**Subject: Final Design and Reclamation Plan for GHP No. 2/Mill Area:
Request for Deviation from Ra-226 Frost Protection and Exposure
Rate Criteria**

Reference: License SUA-648, Docket No. 40-0299, License Condition 61

**REPORT AMENDING
FINAL DESIGN AND RECLAMATION PLAN
GHP NO. 2/MILL AREA**

Gas Hills, Wyoming Site

Figure 4
 Map of Exposure Rate Measurements Used as
 the Basis for the Umetco 2000 Background Report
 Gas Hills, Wyoming Site

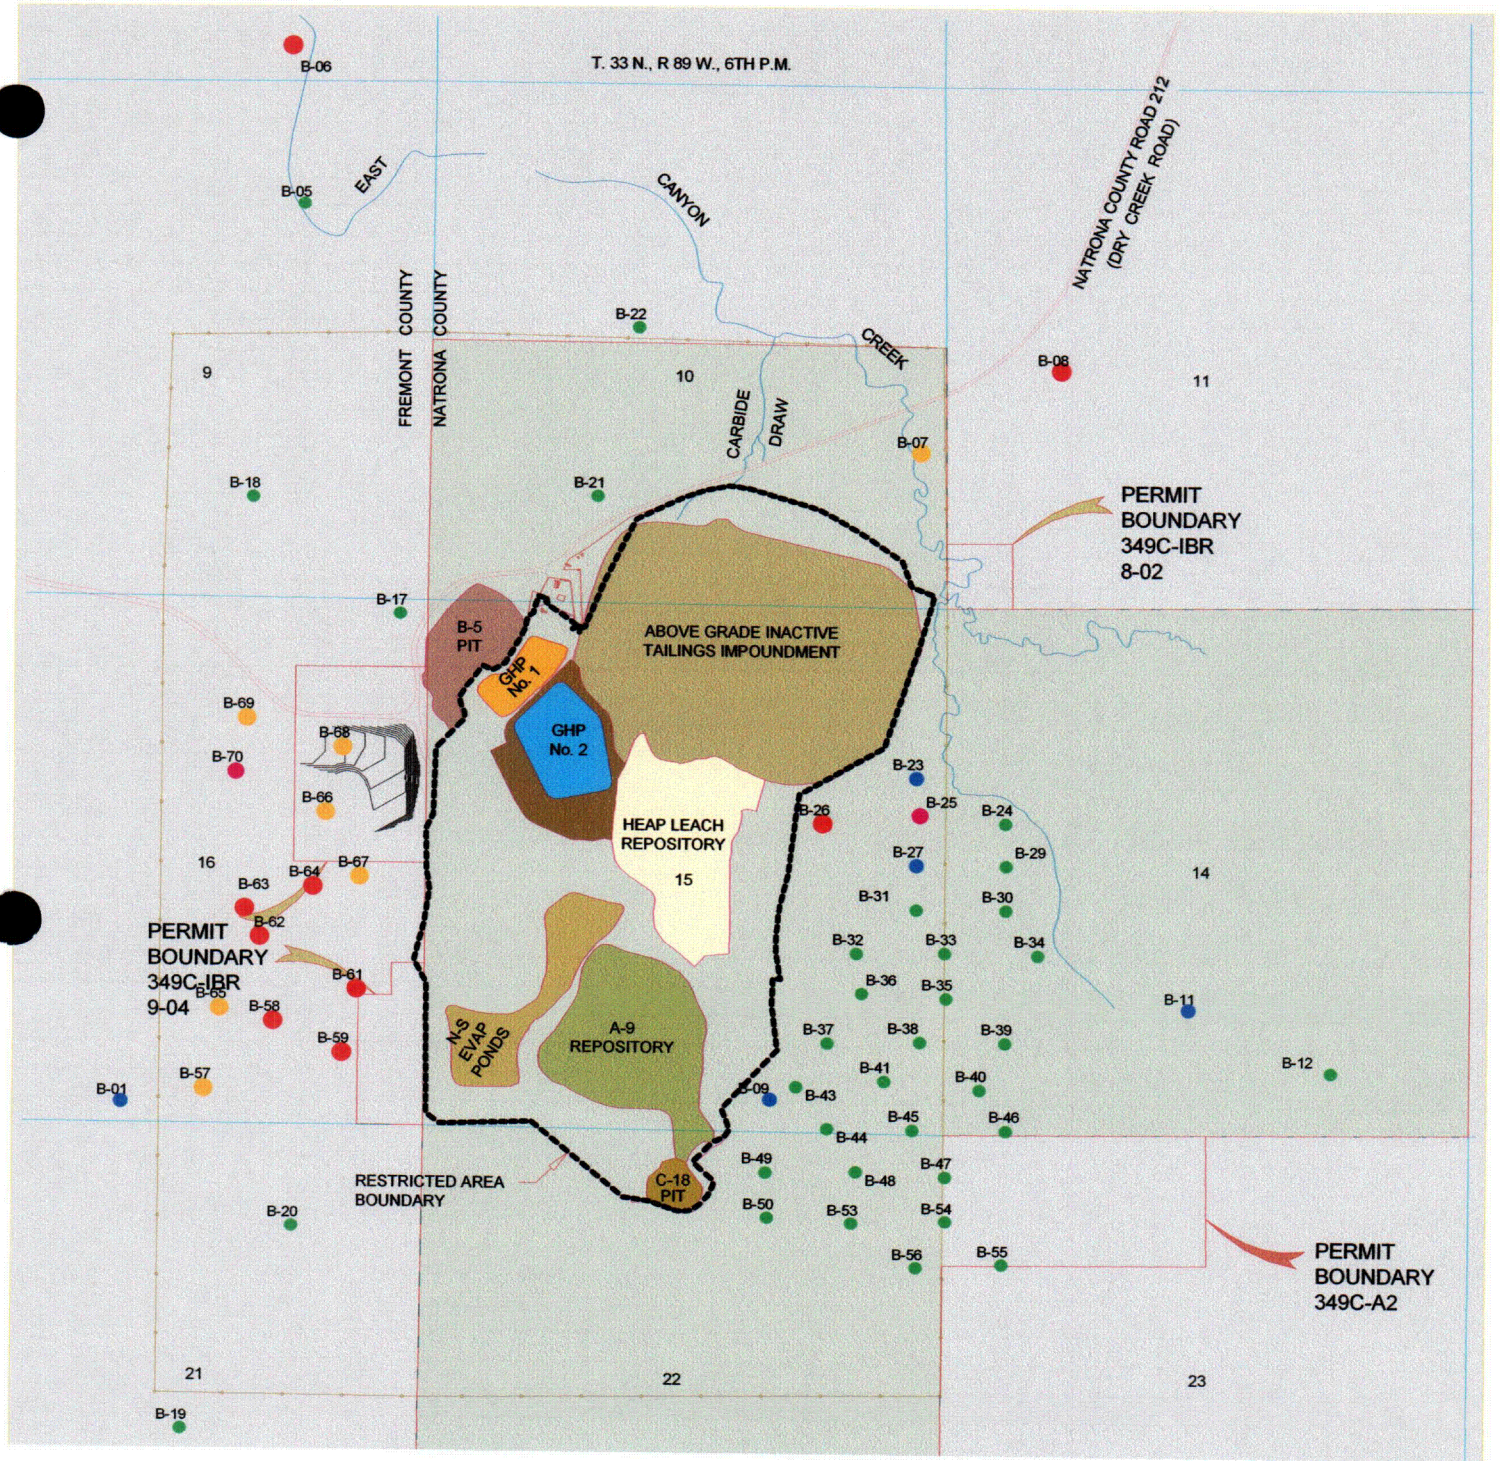
Second, recent increased capabilities in data mapping and visualization techniques have allowed Umetco to better assess the geographic distribution of data. For example, Figure 4 maps the exposure rate data used as the basis for the 30 $\mu\text{R/hr}$ criterion. As shown on this map, a clear spatial pattern is evident. The lower (< 30 $\mu\text{R/hr}$) background rates are found east of the site, but in the area west of the site, corresponding to the Moore Ranch Borrow Area (the source of GHP-2 cover material), the exposure rates are clearly higher, with virtually all exceeding 30 $\mu\text{R/hr}$.
